Service Bulletin

Service Bulletin No. 211, Rev. A

Aircraft Starter Power-Lead Inspection

Figure-1 - **Improper** Starter Installation

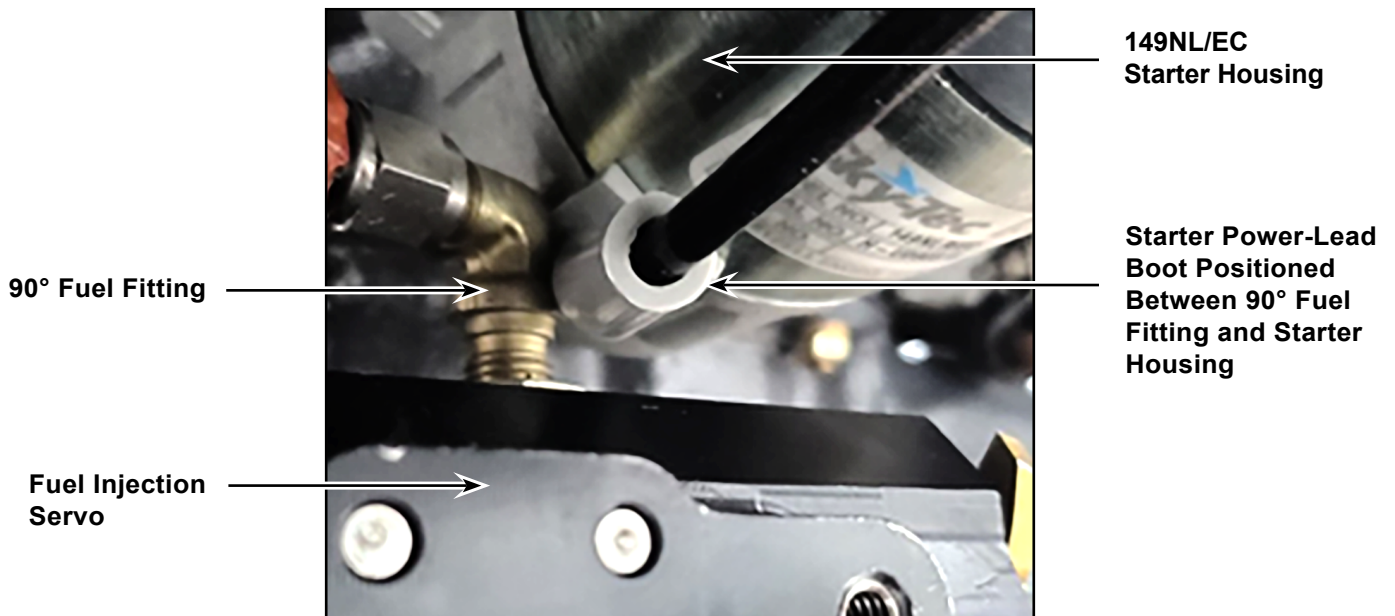
(a) Inspect the starter power-lead against Improper (Fig. 1) and Proper (Fig. 2) installations.

1) Starters found with an improper installation (Fig. 1):

a) Remove the starter assembly in accordance with the latest aircraft/engine maintenance manual and service instructions.

b) Visually inspect the starter power-lead and boot for damage, e.g., chaffing, tears, heat damage, or exposed wire core.

1: If the starter power-lead and/or boot **is** damaged, replace the starter in accordance with the latest aircraft/engine maintenance manual and service instructions.

2: If the starter power-lead and boot are **not** damaged, re-install the starter onto the engine.

WARNING: TO PREVENT DAMAGE TO THE STARTER AND/OR AIRCRAFT, ENSURE TO POSITION THE STARTER POWER-LEAD BOOT BETWEEN THE FUEL INJECTION SERVO 90° FUEL FITTING AND THE STARTER HOUSING, AS SHOWN IN FIG. 2.
